Comments on Ameren’s 2017 IRP, EO-2018-0038
Submitted by Natural Resources Defense Council
February 28, 2018

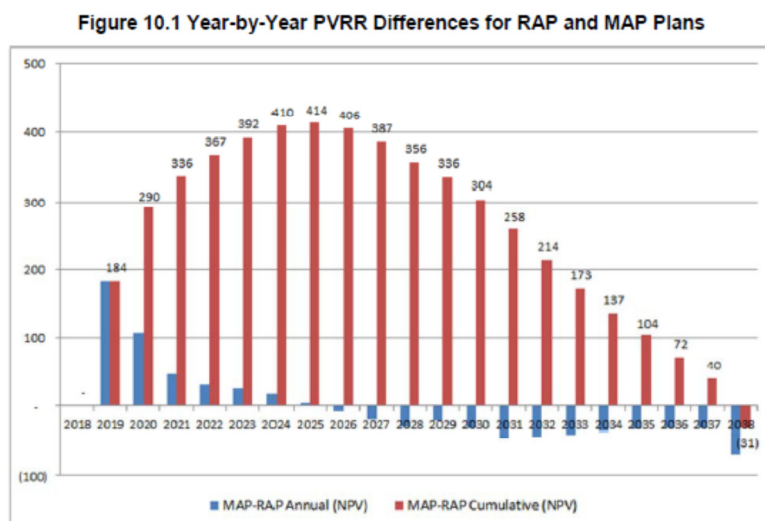
On page 7 of Chapter 10 of the IRP, Ameren gives a detailed explanation of why it chose RAP over MAP despite MAP’s lower PVRR. In summary, the argument is that the MAP scenario has higher revenue requirements until the very last year of the analysis period, and is therefore not worth the risk or the rate impacts. Ameren includes the following chart:

As seen, according to this chart, net benefits aren't positive until 2038. Ameren goes on to say that "the greater net benefits of MAP relative to RAP increase significantly after the end of the planning horizon."

This is a fundamentally unfair way to examine efficiency, which by its nature incurs large Year 1 expenses to produce benefits for an average of 10-15 years down the road. This is evidenced by the fact that after 2038 spending stops, but "the greater net benefits of MAP relative to RAP increase significantly." In order to look at efficiency on an equal footing with supply side options, Ameren should amortize the cost of efficiency over the average measure life of the efficiency programs. This is in fact how efficiency programs are financed in some jurisdictions, including how Ameren Illinois now funds efficiency programs in its neighboring Illinois territory. Using amortization as is done for new supply-side resources would significantly lower the Year 1 rate impact, and would show lower PVRR from MAP for the full planning horizon.
